[1] **GREEN LINE REVISION NO. 1**
8/2/2010

MD 586 (VEIRS MILL RD) AND ATLANTIC AVENUE
TRAFFIC SIGNAL RECONSTRUCTION
ROCKVILLE, MD

GEOMETRIC PLAN SHEET

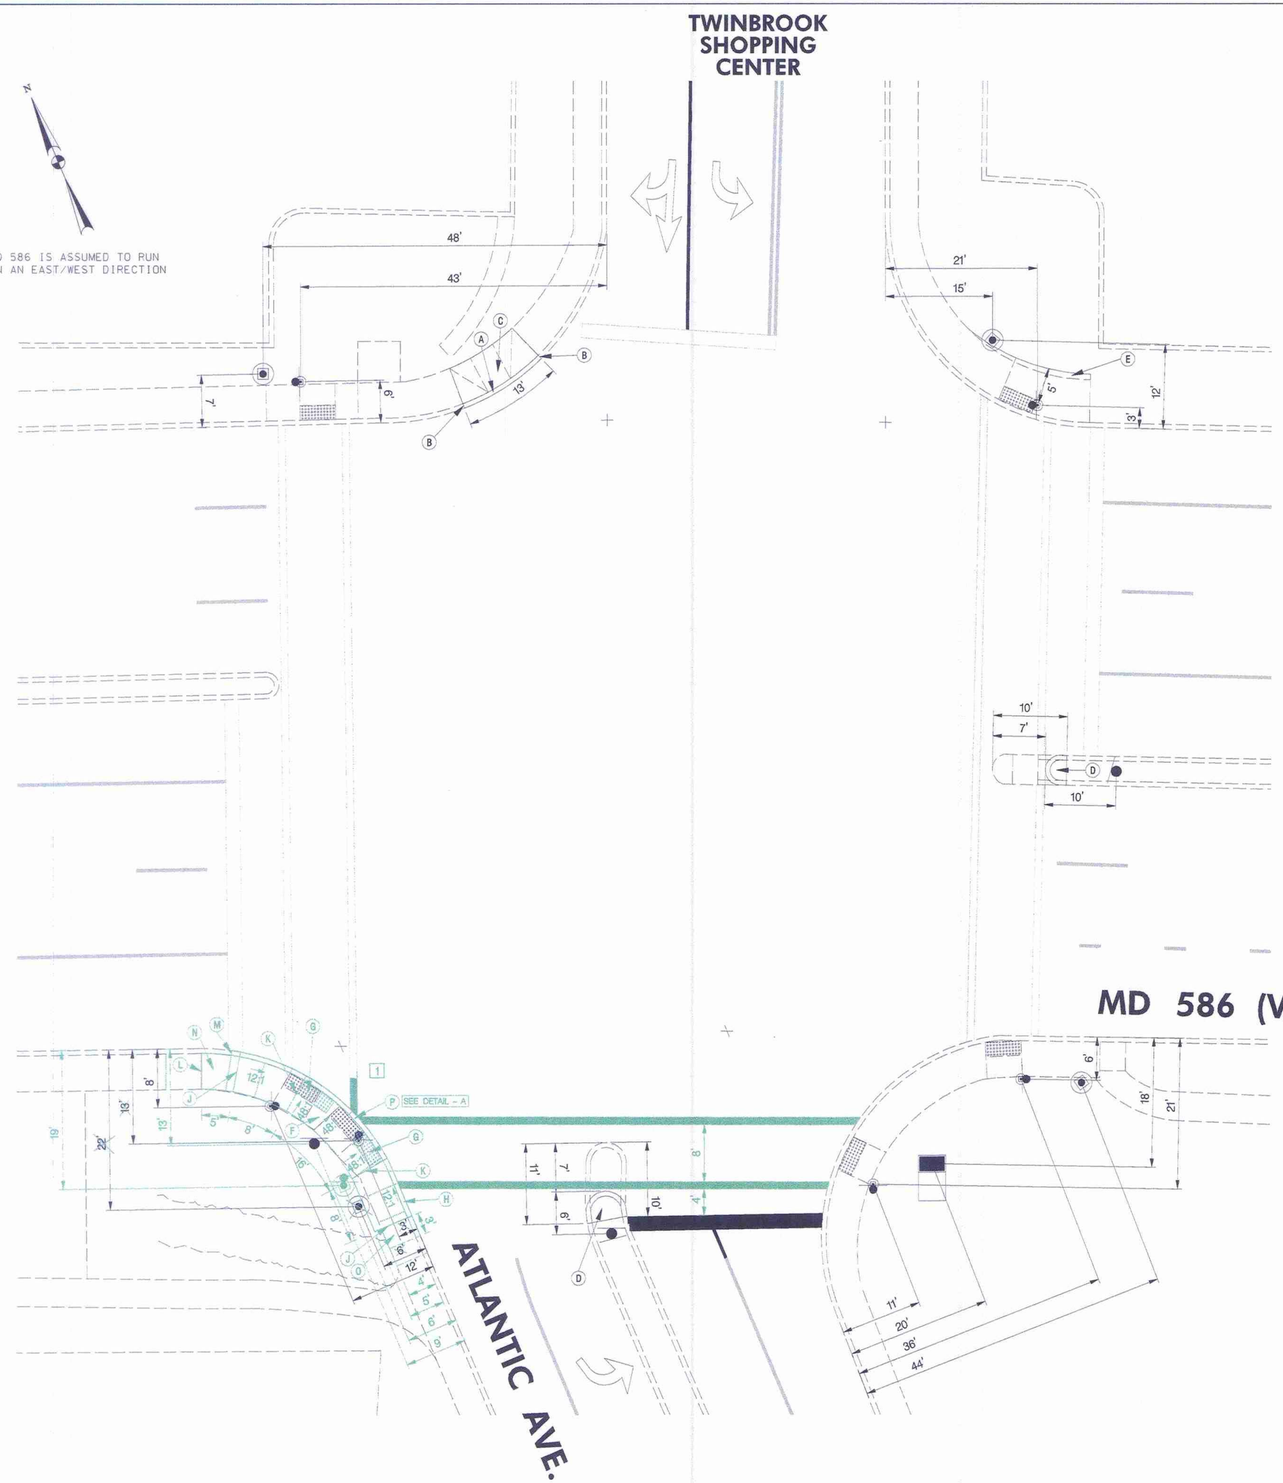
INSTALL ADA RAMPS IN SOUTHEAST QUADRANT AND RELOCATE MAST ARM POLE

D. CUT BACK EXISTING MEDIAN NOSE AND INSTALL NEW TYPE 'A' ISOMETRIC-NOSE DOWN (STANDARD NO. MD 645.01)
E. INSTALL 5 INCH CONCRETE SIDEWALK (MATCH EXISTING SIDEWALK GRADE).
[1] F. INSTALL PARALLEL SIDEWALK RAMP (STANDARD NO. MD 655.12).
